PROPOSED REPLACEMENT BUILDING
AT 25 THE RESERVOIR, SURFLEET SEAS END, PE11 4DJ
ADDENDUM TO FLOOD RISK ASSESSMENT

Front Elevation

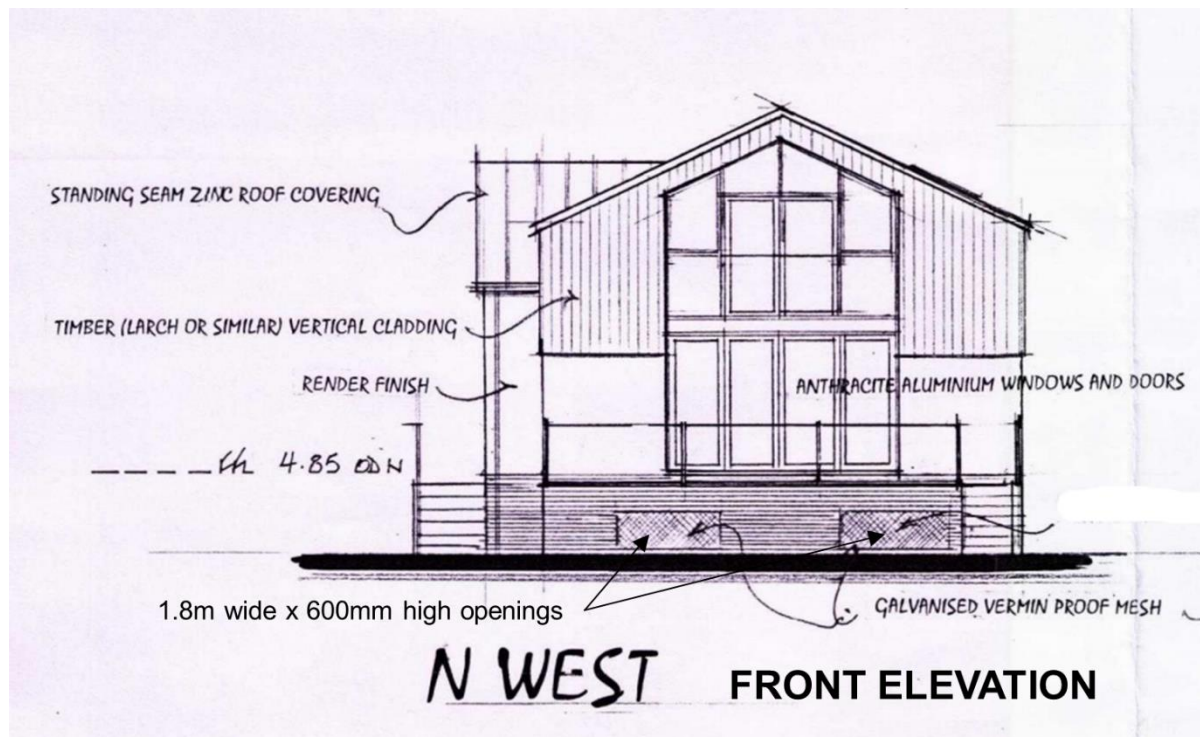
The Environment Agency have objected to the flood risk assessment dated 4th July 2021.

Details are shown below of the proposed apertures in the brickwork beneath ground floor level which will allow flood water to flow under the building and therefore will satisfy the condition that no flood plain capacity is lost.

All below ground level walls should have 1.8 metre long x 600mm deep openings to allow flood water to enter and leave the underside of all of the building. Examples of these are shown on the elevations taken from the architects drawing which are shown below. A building located on the north side of the River Glen at Surfleet Reservoir has recently been approved by the District Council with a similar design to this.
